DSP-06001-03

The Commons at Addison Road Metro

STAFF REPORT

SUBJECT: Detailed Site Plan DSP-06001-03
Type 2 Tree Conservation Plan TCP2-013-2019
The Commons at Addison Road Metro

Figure 3: Proposed Freestanding Sign

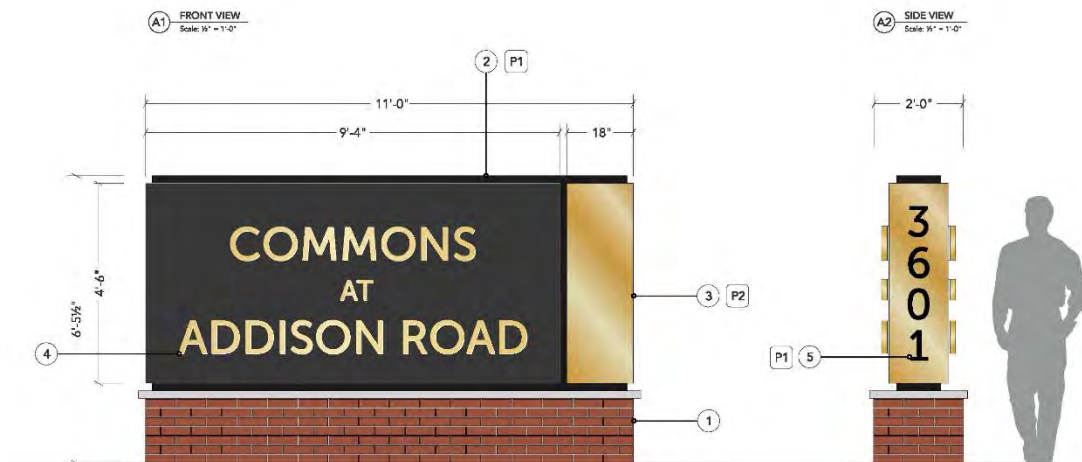
One six-foot-tall, double-faced, freestanding sign is proposed along Addison Road, near the entrance to the site. The sign is constructed of aluminum and mounted on a brick veneer base. The sign includes back-lit, gold leaf lettering on a black background. The 11-foot-wide sign includes landscaping at its base for seasonal interest and has been found acceptable, with the exception of the illumination, which is not allowed by the D-D-O Zone; however, an amendment to allow the sign's illumination is recommended for approval.
